EDWIN I. HATCH NUCLEAR PLANT UNIT 1

AMENDMENT TO FACILITY OPERATING LICENSE

Amendment No. 23  
License No. DPR-57

SAFETY EVALUATION BY THE OFFICE OF NUCLEAR REACTOR

Figure 1 Plug Installed in Core Plate

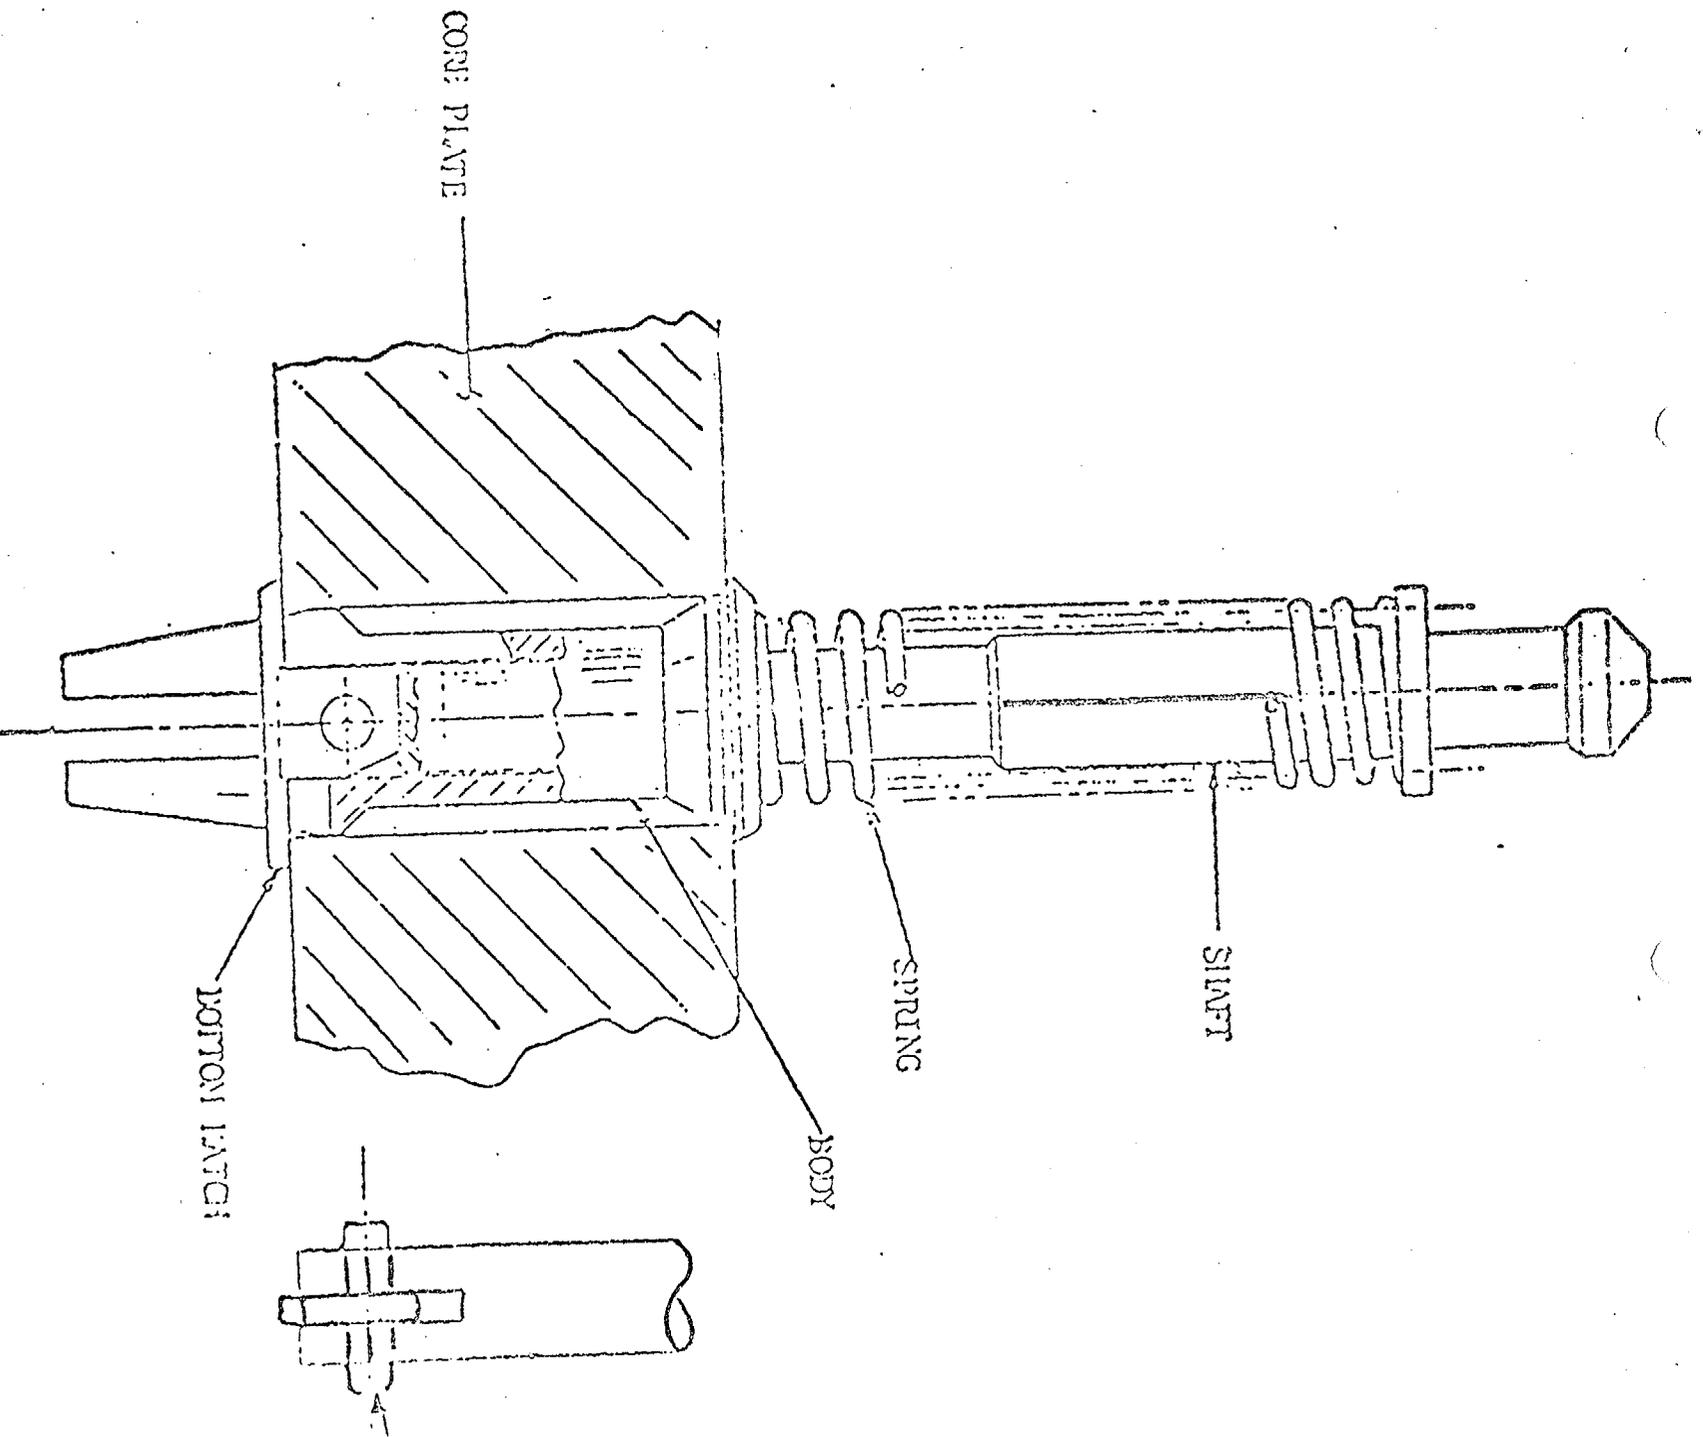
The plug consists of five basic parts, as shown in Figure 1. Identical plugs have previously been installed at Vermont Yankee, Pilgrim, Cooper and Duane Arnold. The body provides a means of guiding the device into the bypass flow holes as well as a shoulder to support the plug and form a seal against water flow. The shaft extends through the body. A knob is provided at the top of the shaft to provide a means of grabbing the plug during installation and extraction. At the bottom, the latch is attached to the shaft by a pin. The latch is free to rotate during installation. The spring acts against the body and shaft during normal operation to provide the force necessary to offset the pressure differential acting on the body.

During installation, the plug has its latch rotated 90 degrees from its installed position and withdrawn and locked in the body. The shaft is gripped by the installation tool, and the plug is inserted into the bypass flow holes. The body engages the rim of the hole. The shaft is pushed to its full extension, thus lowering and unlocking the latch below the underside of the core plate. The latch then rotates 90 degrees and bears on the bottom of the core plate. After insertion, the plug is pulled with about 30-pound force to test the placement.

The plug can be removed by gripping the top of the shaft with an extracting tool and applying a force of about 500 pounds. The latch's legs will be plastically deformed and the entire plug withdrawn. The plugs previously installed at Vermont Yankee were removed with no abnormalities or loose pieces reported. The force required for removal varied from 500 to 1300 pounds.

Based on a review of the design, the installation methods, and the previously successful operating experience at Vermont Yankee, Pilgrim, and Duane Arnold, we conclude that the plugs can be installed without damage to core components, that they will not fail so as to result in loose parts in the core or result in unplugging of the bypass flow holes, and that they can be removed, if necessary, without damage to core components. Thus, the modification is reversible.

Accordingly, we conclude that the installation of the plugs is acceptable. Operation with plugged bypass holes is still under review and will be the subject of a separate licensing action.
